PRODUCT SAFETY NOTICE

LADDER SAFETY SYSTEMS USING 3/8 INCH 7X19 STRAND GALVANIZED CABLE

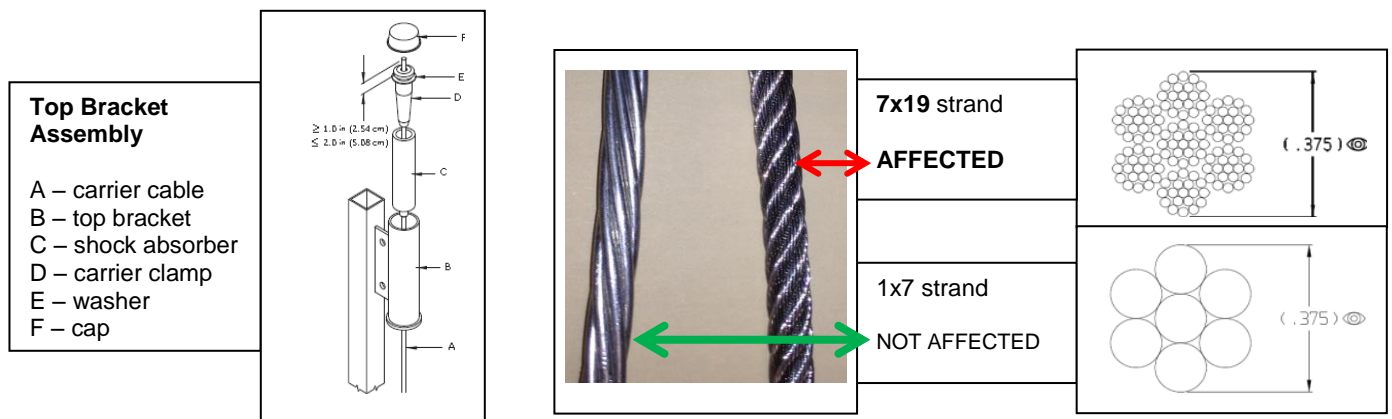
This Notice concerns the DBI-SALA Lad-Saf™ Flexible Cable Ladder Safety System, also known as a 'Safety Climb System.' Capital Safety has received a limited number of reports of **7x19** strand carrier cable slippage from the carrier clamp in the top bracket of these ladder safety systems. Although this top bracket design has been used in the market for more than 40 years without incident, the reported slippage raises the potential for injury to users of affected systems.

- **systems using 3/8 inch 7x19 strand galvanized cable, with**
- **top bracket assemblies (including carrier clamps) purchased from Capital Safety between September 1, 2013 and May 13, 2014**

A top bracket assembly is depicted below, with diagrams and photos of **7x19** strand cable (affected) and 1x7 strand cable (not affected).

Capital Safety recommends that users: (1) inspect their systems prior to next use to determine whether 3/8 inch 7x19 strand cable is used and, if so, (2) determine whether the top bracket assemblies were purchased within the above date range.

If an affected Lad-Saf system or Safety Climb System is found, do not use the system until you have contacted Capital Safety Customer Service at 1-800-328-6146 (ext. 2012), or email us at csq.lss.inquiries@capitalsafety.com. We will answer inquiries and provide guidance on how to proceed.
